Subject: Gas Works Park Cracking Towers – Pedestrian Appurtenance Removal Certificate of

Approval Application

Subject: Gas Works Park Cracking Towers - Pedestrian Access Elements Removal

GAS WORKS PARK "CRACKING TOWERS": EMERGENCY SELECTIVE DECONSTRUCTION

SPR Proposed Removals

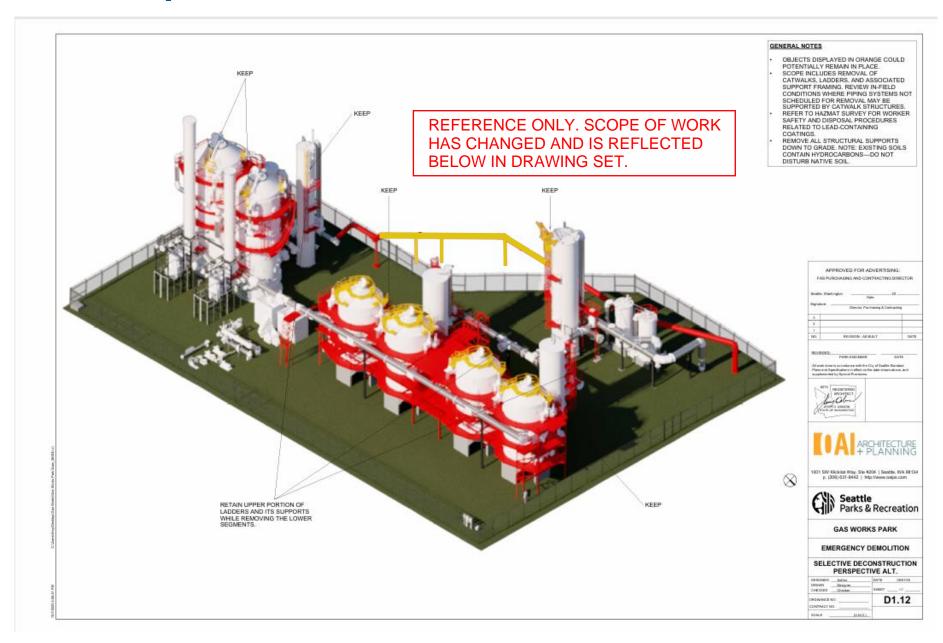
Summary Proposal

- 1) Remove all pedestrian appurtenances and one pipe that extends beyond the fence; SPR will attempt to save appurtenances on the uppermost level of the towers and portion(s) of the pipe, if possible. A final determination will be made in the field based on the actual condition and stability of the appurtenances and pipe segment(s).

- 2) Compile photo-document the towers with the pedestrian appurtenances in place.
- 3) Once the appurtenances have been removed, repaint the towers and paint the shadow lines of the catwalks and ladders as a reference to the elements that have been removed.

- 4) Continue to monitor the site for evidence of access and graffiti.
- 5) Lighting to highlight the towers and further discourage access and security camera(s) to monitor the site and track access attempt(s) will be installed once the appurtenances have been removed under a separate Certificate of Approval request.

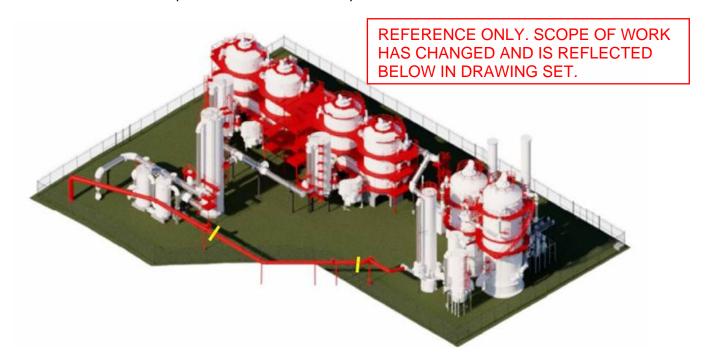
- Is it possible to reconfigure the perimeter fence to enclose the elevated pipe on the west side, rather than remove it? We could expand the fence to include the pipe, but that removes open space and adds more fencing around the towers which would end up blocking views of that pipe. Due to the similarity of heights, that pipe would not be visible if the fence is extended around it and the pipe remains a potential safety hazard to SPR crews doing maintenance inside the fence. If left in place, the pipe continues to present a potential safety hazard. It could be extremely

compromised from the inside with no visible evidence on the exterior. Another option would be to remove the middle section of the pipe between the yellow bars on the following graphic. SPR could commit to saving portions of the pipe that are within the Cracking Tower fence, pending field verification by SPR's Consultant, staff and selected contractor that the remnants and supports are safe and structurally sound and don't contain any hazardous materials.
